SCEC – K&A Reviewed
Code B – Approved with Comments (Do not Resubmit)

PROJECT: JEDDAH OPERA HOUSE

TITLE:
OPERA BUILDING
VERTICAL TRANSPORTATION
PART 004
PLANS - LIFT SHAFT SHEET 01 OF 02 (L12)

DRAWING No: JOH-OTS-S5-01-056-004-ZZ-SD-VT-011000 REV: S00

1 Hoist Way Plan At "B2, G, 1" Floor (Front) - ELEV-L12

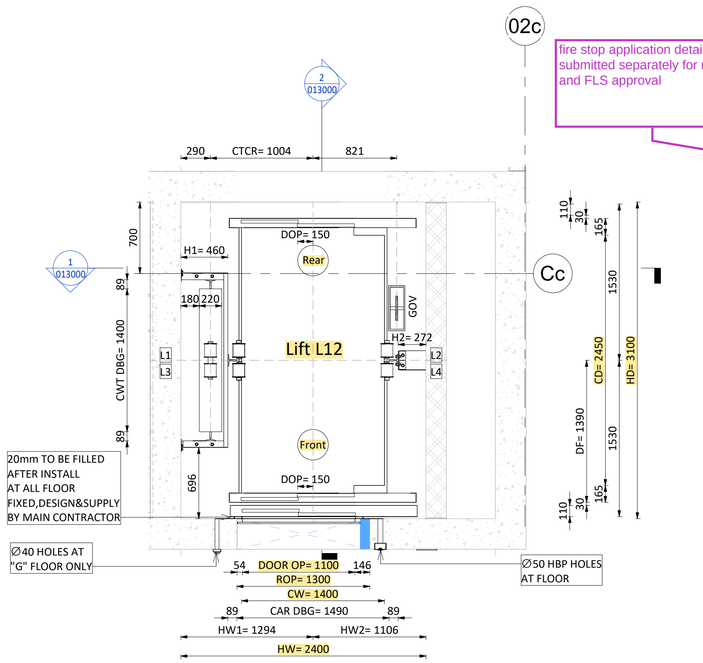
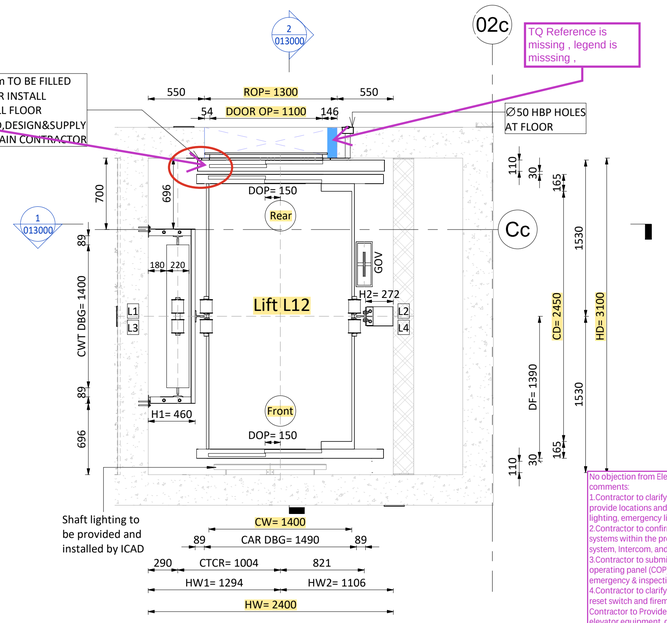
fire stop application detail to be submitted separately for review and FLS approval

TQ Reference is missing , legend is misssing ,

2 Hoist Way Plan At "B1, 2, 4,5" Floor (Rear) - ELEV-L12

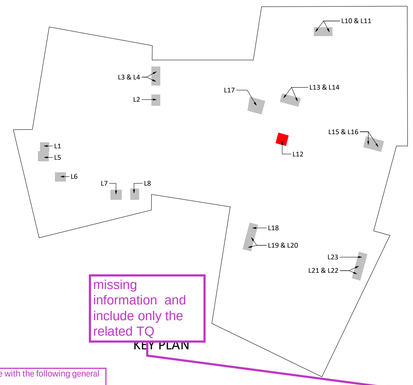
missing information and include only the related TQ

add the letter references TQ-05809 & deviation letter

TITLE: OPERA BUILDING
VERTICAL TRANSPORTATION
PART 004
PLANS - LIFT SHAFT SHEET 02 OF 02 (L12)

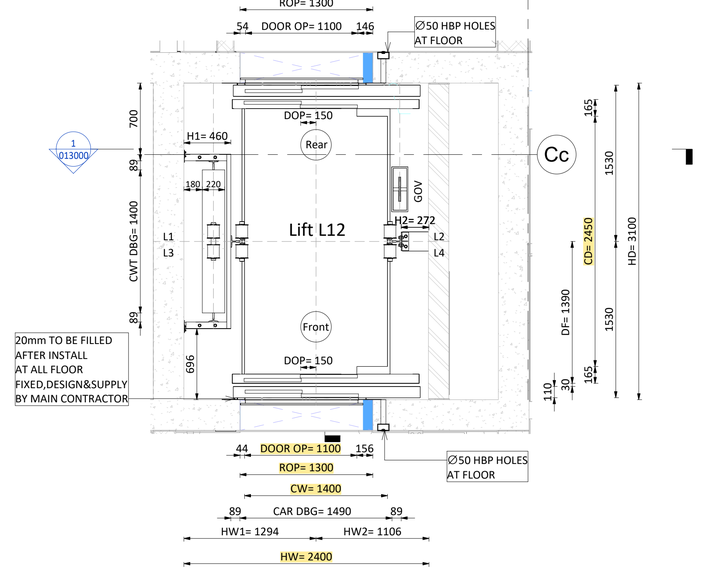
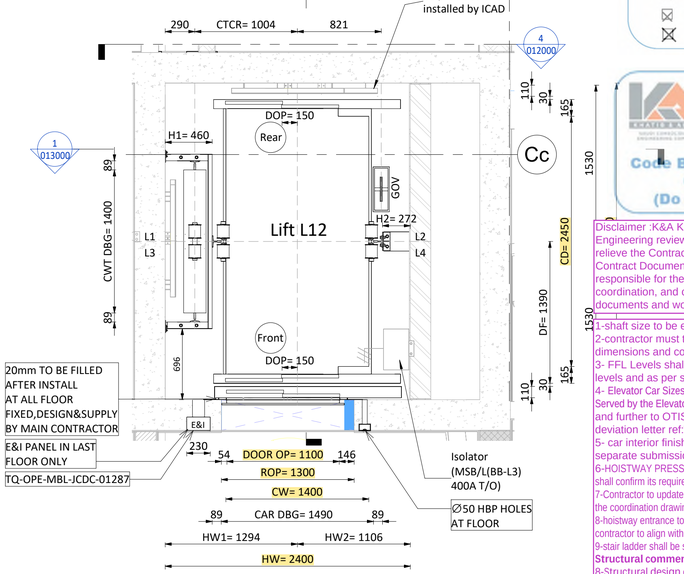
No objection from Electrical side with the following general comments:
1.Contractor to clarify lighting supply requirements and provide locations and provisions for shaft lighting, cabin lighting, emergency lighting, and ventilation fans.
2.Contractor to confirm compatibility with other interfaced systems within the project: BMS, PMS, CCTV, Fire alarm system, Intercom, and cabin speakers as noted on drawings.
3.Contractor to submit wiring diagrams for controller, car operating panel (COP), hall position indicators (HBP), and emergency & inspection panels (E&I).
4.Contractor to clarify the requirements for pit inspection reset switch and fireman service switch installations. (If any Contractor to Provide grounding and earthing details for elevator equipment, guide rails, and machine component.

1-shaft size to be extracted from federated model
2-contractor must take in consideration as built dimensions and conditions prior execution
3- FFL Levels shall match the federated model levels and as per site conditions
4- Elevator Car Sizes/**dimensions** and Floors Being Served by the Elevators shall be as per approved TBE and further to OTIS letter **TQ-05809** and lift deviation letter ref:**TQ-OPE-MBL-JCDC-01330**
5- car interior finishes shall be submitted in a separate submission for approval
6-HOISTWAY PRESSURIZATION is not provided contractor shall confirm its requirement prior execution
7-Contractor to update the missing reference when submitting the coordination drawing with wall finishing
8-hoistway entrance to be verified by contractor by the contractor to align with OTIS proposed drawings
9-stair ladder shall be submitted separately for approval
Structural comments:
8-Structural design of brackets including their anchor bolts into the concrete walls for the lift loads is to be submitted for checking and approval.

Otherwise, evident for its adequacy is to be provided.

9-this note is rejected , it is contractor sole responsibility to submit a complete coordinated shop-drawing connection details with wall finishes ,architraves floor threshold connection and linter/top door connection

MBL to provide a comprehensive Method Statement describing the procedure for filling all gaps and correcting / adjusting the rough openings for doors.

DRAWING No: JOH-OTS-S5-01-056-004-ZZ-SD-VT-011001 REV: S00

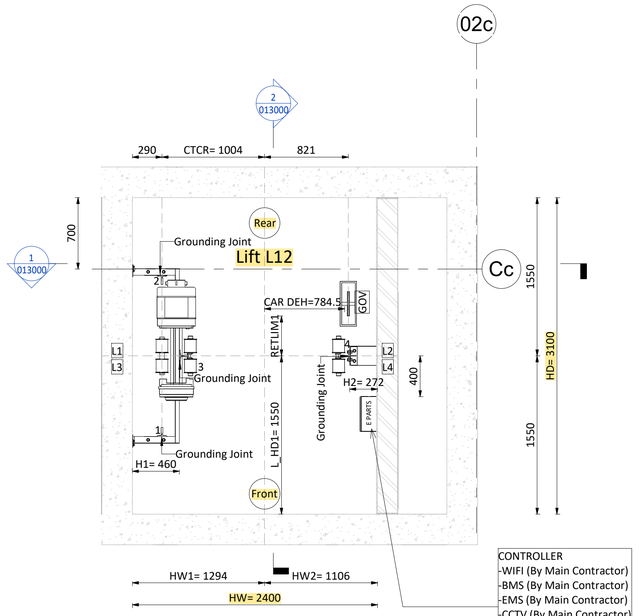
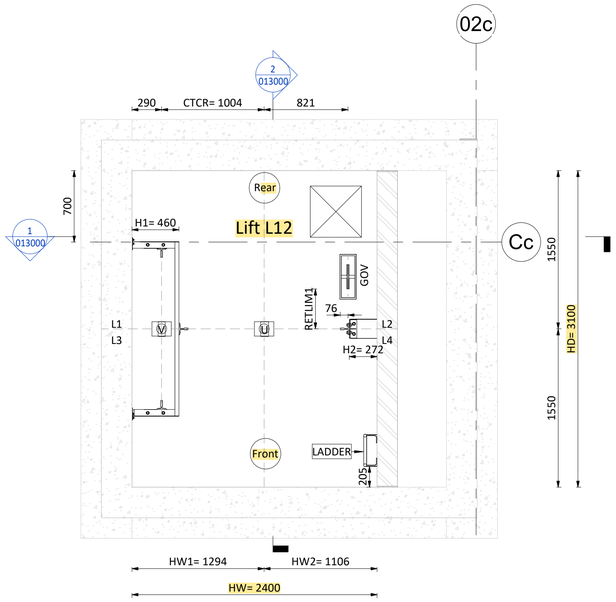
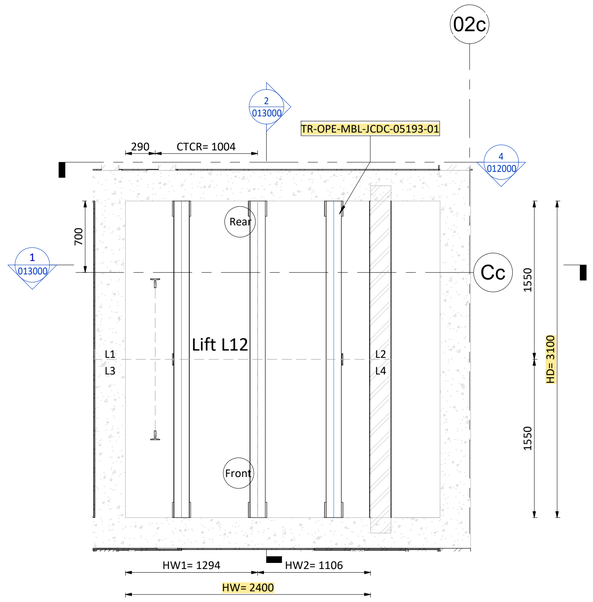
No objection from Electrical side with the following general comments:
1.Contractor to clarify lighting supply requirements and provide locations and provisions for shaft lighting, cabin lighting, emergency lighting, and ventilation fans.
2.Contractor to confirm compatibility with other interfaced systems within the project: BMS, PMS, CCTV, Fire alarm system, Intercom, and cabin speakers as noted on drawings.
3.Contractor to submit wiring diagrams for controller, car operating panel (COP), hall position indicators (HBP), and emergency & inspection panels (E&I).
4.Contractor to clarify the requirements for pit inspection reset switch and fireman service switch installations. (If any Contractor to Provide grounding and earthing details for elevator equipment, guide rails, and machine component.

missing information and include only the related TQ

add the letter references TQ-05809 & deviation letter

9-this note is rejected , it is contractor sole responsibility to submit a complete coordinated shop-drawing connection details with wall finishes ,architraves floor threshold connection and liner/top door connection

1-shaft size to be extracted from federated model
2-contractor must take in consideration as built dimensions and conditions prior execution
3- FFL Levels shall match the federated model levels and as per site conditions
4- Elevator Car Sizes/**dimensions** and Floors Being Served by the Elevators shall be as per approved TBE and further to OTIS letter **TQ-05809** and lift deviation letter ref:**TQ-OPE-MBL-JCDC-01330**
5- car interior finishes shall be submitted in a separate submission for approval
6-HOISTWAY PRESSURIZATION is not provided contractor shall confirm its requirement prior execution
7-Contractor to update the missing reference when submitting the coordination drawing with wall finishing
8-hoistway entrance to be verified by contractor by the contractor to align with OTIS proposed drawings
9-stair ladder shall be submitted separately for apporval
Structural comments:
8-Structural design of brackets including their anchor bolts into the concrete walls for the lift loads is to be submitted for checking and approval.

Otherwise, evident for its adequacy is to be provided.

DRAWING No: JOH-OTS-S5-01-056-004-ZZ-SD-VT-012000 REV: S00

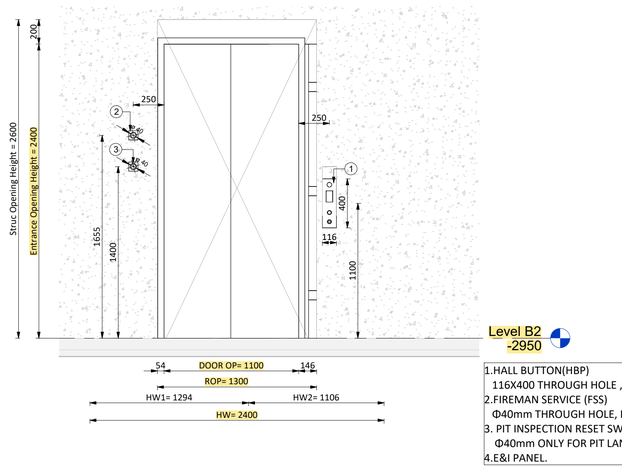
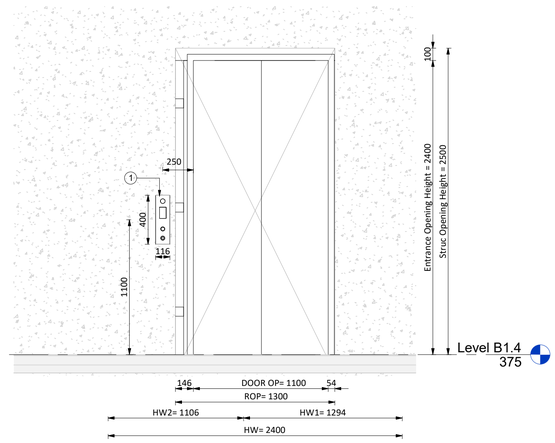
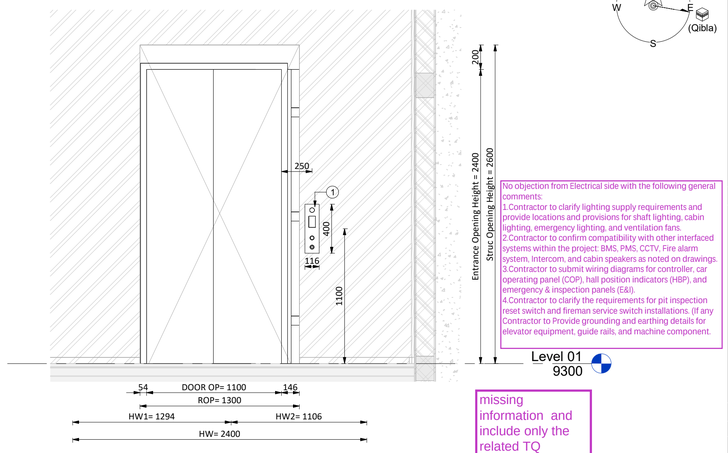
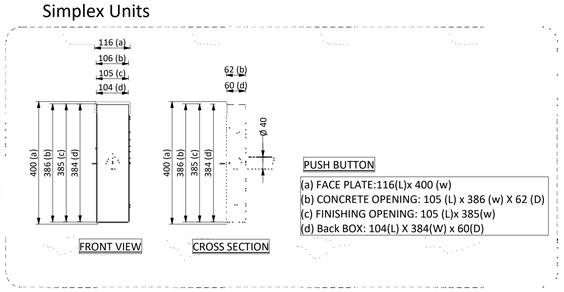
No objection from Electrical side with the following general comments:
1.Contractor to clarify lighting supply requirements and provide locations and provisions for shaft lighting, cabin lighting, emergency lighting, and ventilation fans.
2.Contractor to confirm compatibility with other interfaced systems within the project: BMS, PMS, CCTV, Fire alarm system, Intercom, and cabin speakers as noted on drawings.
3.Contractor to submit wiring diagrams for controller, car operating panel (COP), hall position indicators (HBP), and emergency & inspection panels (E&I).
4.Contractor to clarify the requirements for pit inspection reset switch and fireman service switch installations. (If any Contractor to Provide grounding and earthing details for elevator equipment, guide rails, and machine component.

missing information and include only the related TQ

add the letter references TQ-05809 & deviation letter

MBL to provide a comprehensive Method Statement describing the procedure for filling all gaps and correcting / adjusting the rough openings for doors.

1-shaft size to be extracted from federated model
2-contractor must take in consideration as built dimensions and conditions prior execution
3- FFL Levels shall match the federated model levels and as per site conditions
4- Elevator Car Sizes/**dimensions** and Floors Being Served by the Elevators shall be as per approved TBE and further to OTIS letter **TQ-05809** and lift deviation letter ref:**TQ-OPE-MBL-JCDC-01330**
5- car interior finishes shall be submitted in a separate submission for approval
6-HOISTWAY PRESSURIZATION is not provided contractor shall confirm its requirement prior execution
7-Contractor to update the missing reference when submitting the coordination drawing with wall finishing
8-hoistway entrance to be verified by contractor by the contractor to align with OTIS proposed drawings
9-stair ladder shall be submitted separately for approval
Structural comments:
8-Structural design of brackets including their anchor bolts into the concrete walls for the lift loads is to be submitted for checking and approval.

DRAWING No: JOH-OTS-S5-01-056-004-ZZ-SD-VT-013000 REV: S00

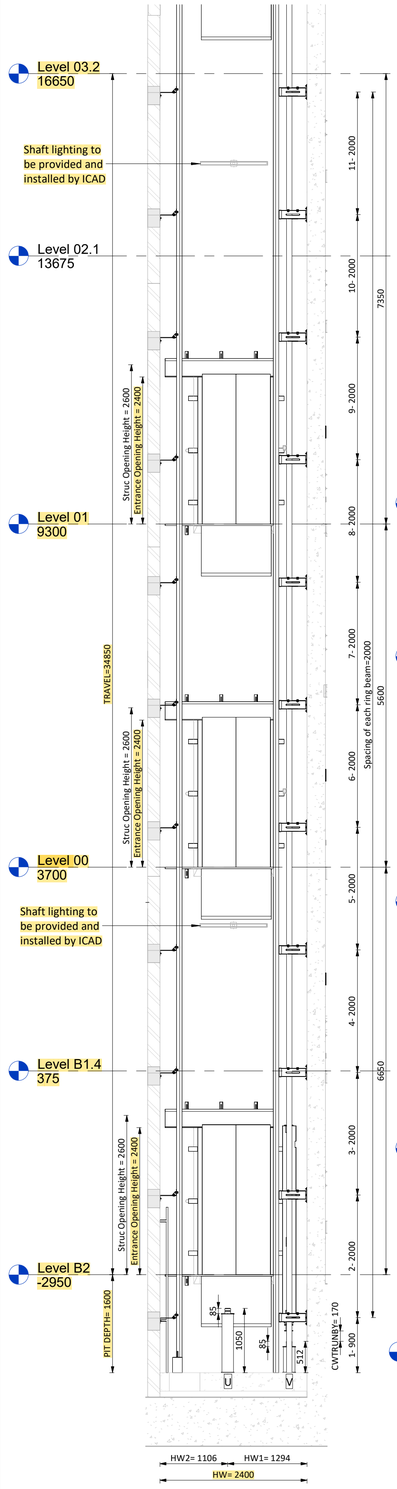
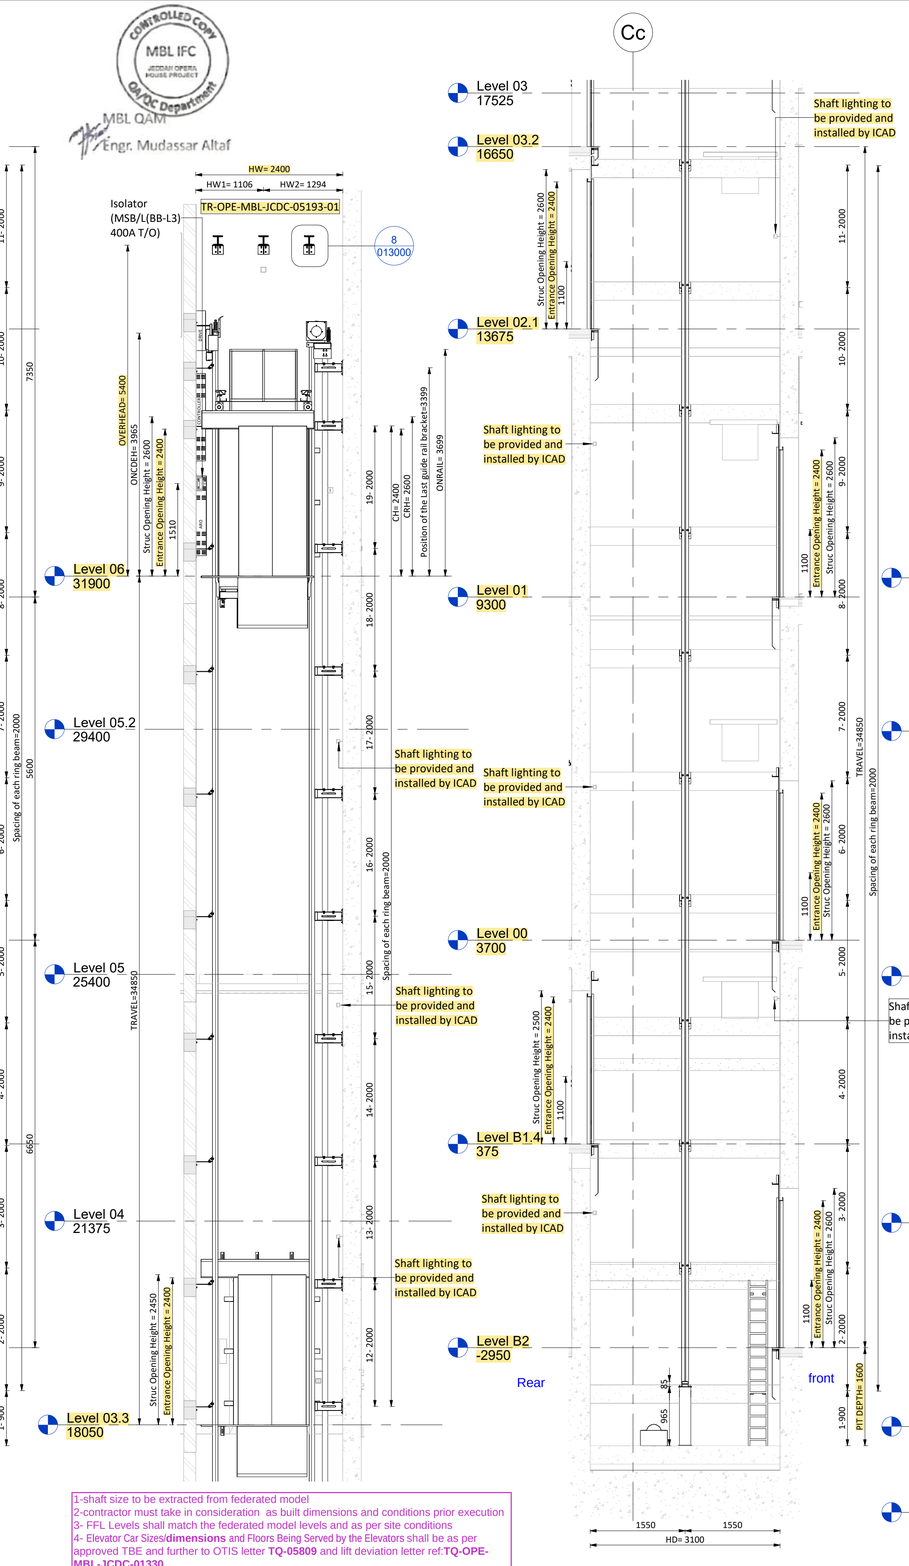
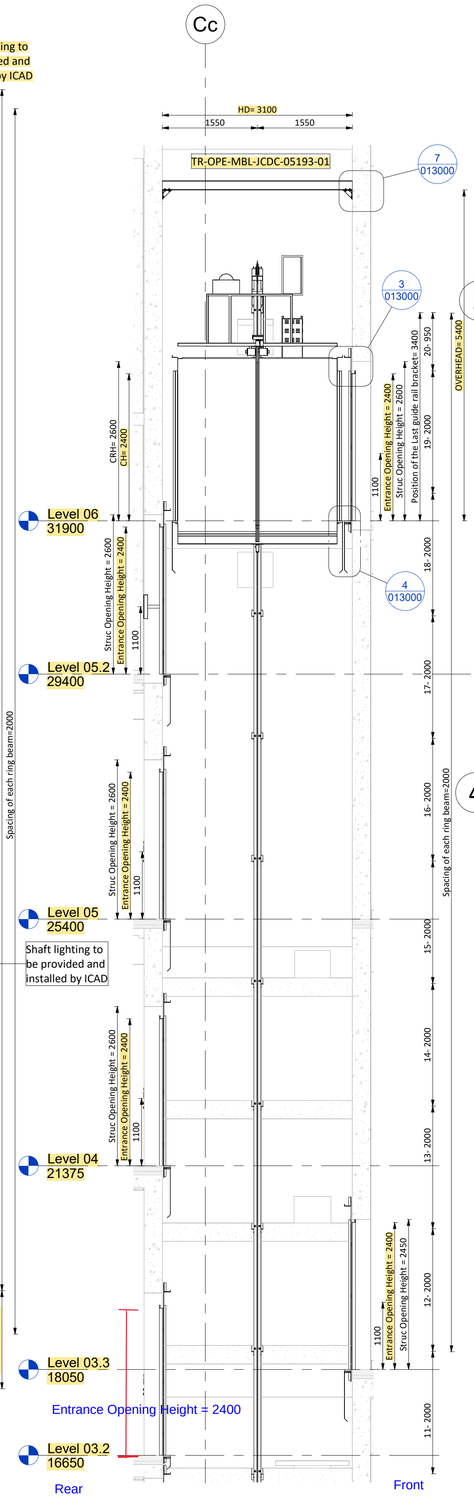
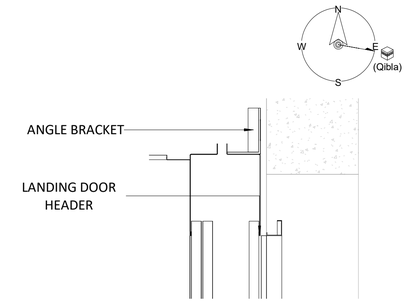
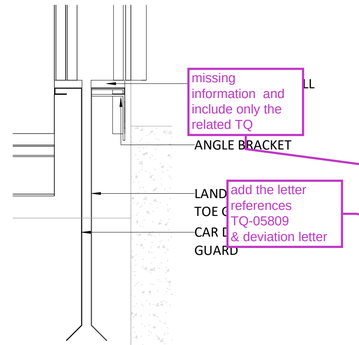
1-shaft size to be extracted from federated model
2-contractor must take in consideration as built dimensions and conditions prior execution
3- FFL Levels shall match the federated model levels and as per site conditions
4- Elevator Car Sizes/**dimensions** and Floors Being Served by the Elevators shall be as per approved TBE and further to OTIS letter **TQ-05809** and lift deviation letter ref:**TQ-OPE-MBL-JCDC-01330**
5- car interior finishes shall be submitted in a separate submission for approval
6-HOISTWAY PRESSURIZATION is not provided contractor shall confirm its requirement prior execution
7-Contractor to update the missing reference when submitting the coordination drawing with wall finishing
8-hoistway entrance to be verified by contractor by the contractor to align with OTIS proposed drawings
9-stair ladder shall be submitted separately for approval
Structural comments:
8-Structural design of brackets including their anchor bolts into the concrete walls for the lift loads is to be submitted for checking and approval.

Otherwise, evident for its adequacy is to be provided.

No objection from Electrical side with the following general comments:
1.Contractor to clarify lighting supply requirements and provide locations and provisions for shaft lighting, cabin lighting, emergency lighting, and ventilation fans.
2.Contractor to confirm compatibility with other interfaced systems within the project: BMS, PMS, CCTV, Fire alarm system, Intercom, and cabin speakers as noted on drawings.
3.Contractor to submit wiring diagrams for controller, car operating panel (COP), hall position indicators (HIP), and emergency & inspection panels (E&I).
4.Contractor to clarify the requirements for pit inspection reset switch and fireman service switch installations. (If any Contractor to Provide grounding and earthing details for elevator equipment, guide rails, and machine component.
